# **20 North Sewall's Point Road**

**TOWN OF SEWALL'S POINT**

Date 9-15-05 BUILDING PERMIT NO. 7764  
 Building to be erected for RUCKS Type of Permit SFR  
 Applied for by MASTERPIECE BUILDERS (Contractor) Building Fee 6720.00  
 Subdivision INDIANWIC EAST Lot 7 Block \_\_\_\_\_ Radon Fee 4598.20  
 Address 20 N. SEWALL'S POINT ROAD Impact Fee 47.89  
 Type of structure SFR A/C Fee 120.00  
 PRINT QUAL. NAME: JEFF POWERS Electrical Fee 120.00  
 ST LIC #: CGC 048543 Plumbing Fee 120.00  
 Parcel Control Number: Roofing Fee 120.00  
35374100300000070410000 Other Fees (b% P.R.) 720.00  
 Amount Paid \_\_\_\_\_ Check # \_\_\_\_\_ Cash \_\_\_\_\_ TOTAL Fees 12,566.09  
 Total Construction Cost \$ 700,000

Plan Reviewer: Gene Simmons

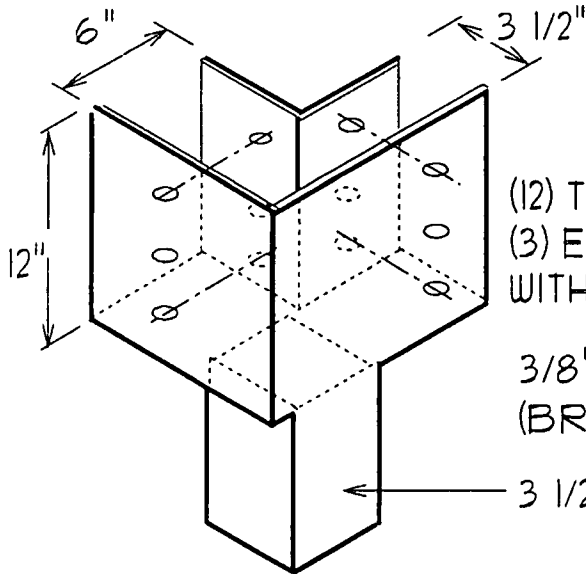
1. It is acceptable that the steel in the B3 beams over the summer kitchen area have #6 bars in lieu of #5 bars as shown on the permitted plans.
2. It is acceptable the three rear porch columns are round instead of square. The vertical steel remains the same.
3. It is acceptable that there is a #7 bar in lieu of a #6 bar in the top course of the composite tie beam to the right of the entry door.

Job 05-1863G	Truss T57	Truss Type ROOF TRUSS	Qty 1	Ply 1	MASTERPIECE / RUCKS - GARAGE
-----------------	--------------	--------------------------	----------	----------	------------------------------

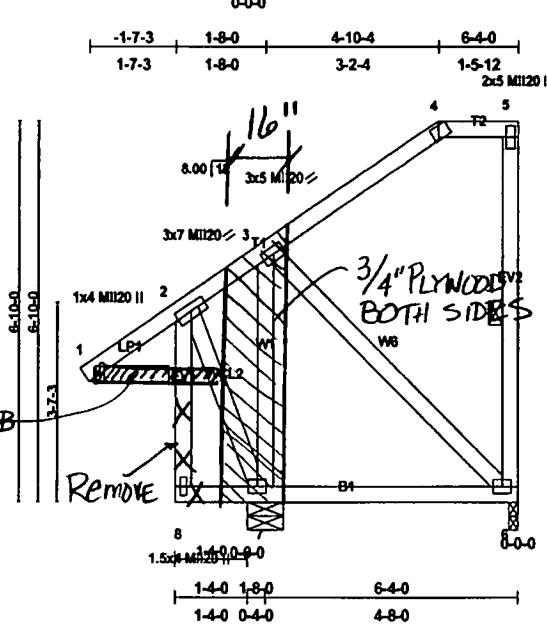
REMOVE

FLOOR TRUSS REPAIR DETAIL

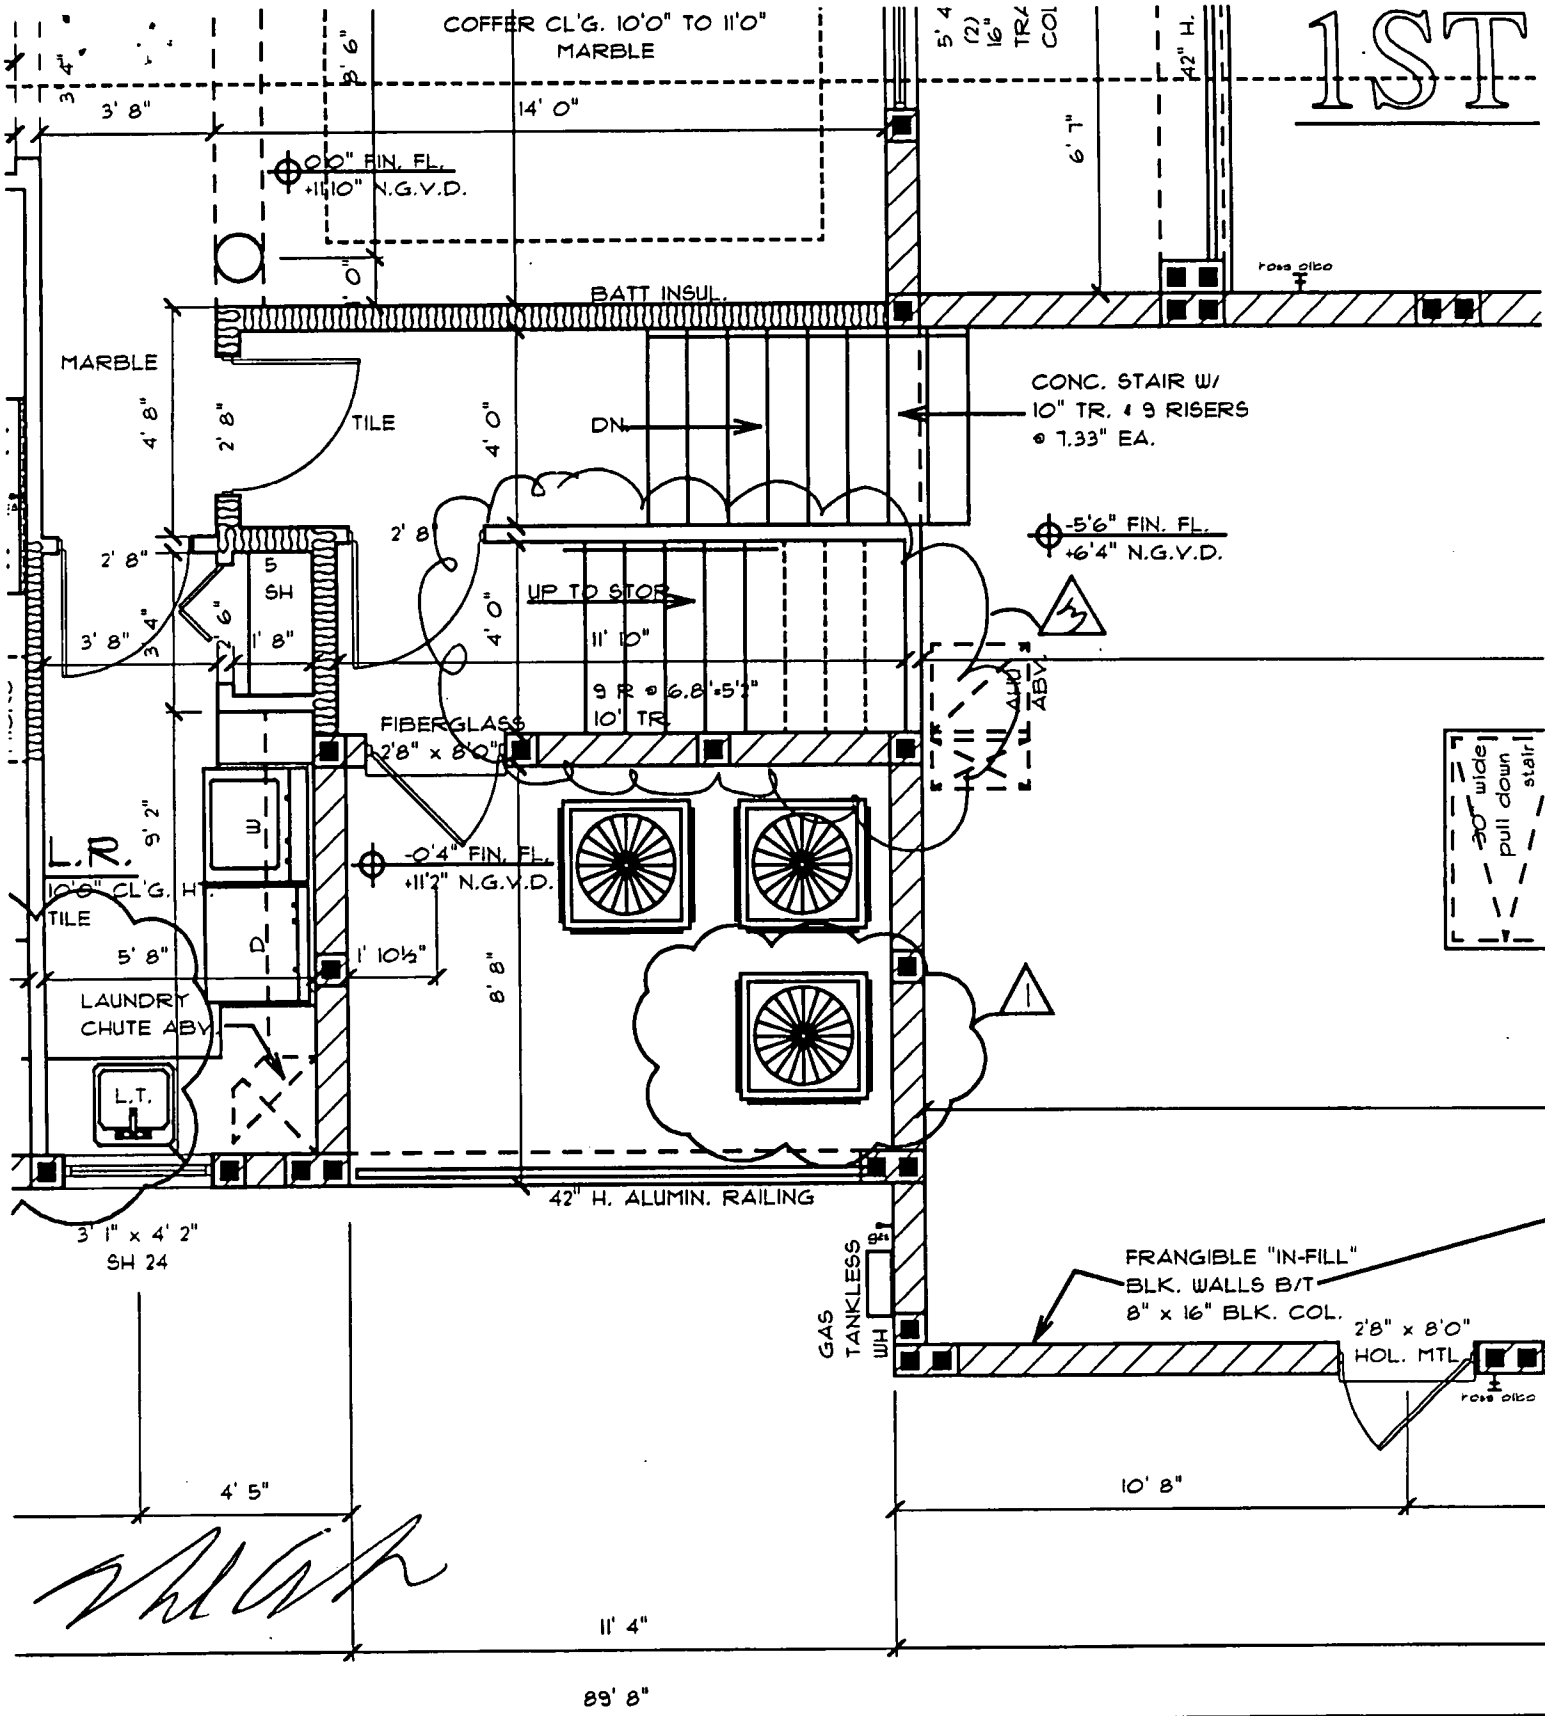
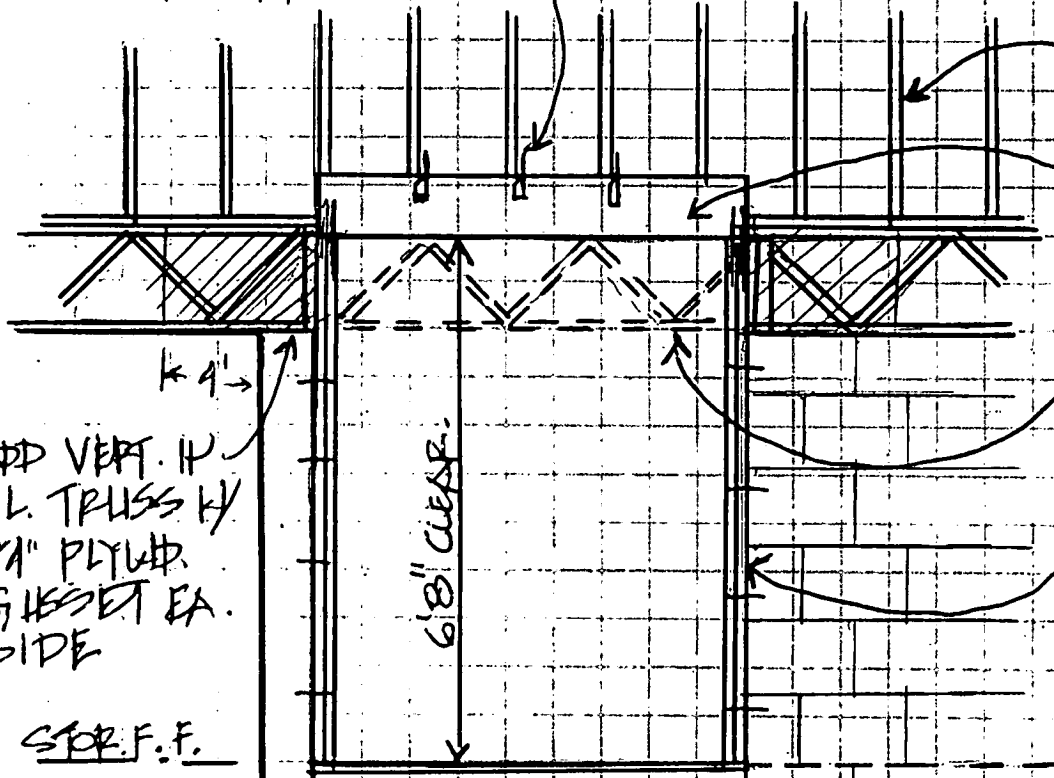
REMOVE PORTION OF  
EXIST. FL. TRUSS

ADD VERT. 1/2  
FL. TRUSS BY  
3/4\" PLYWOOD  
GUSSET EA.  
SIDE
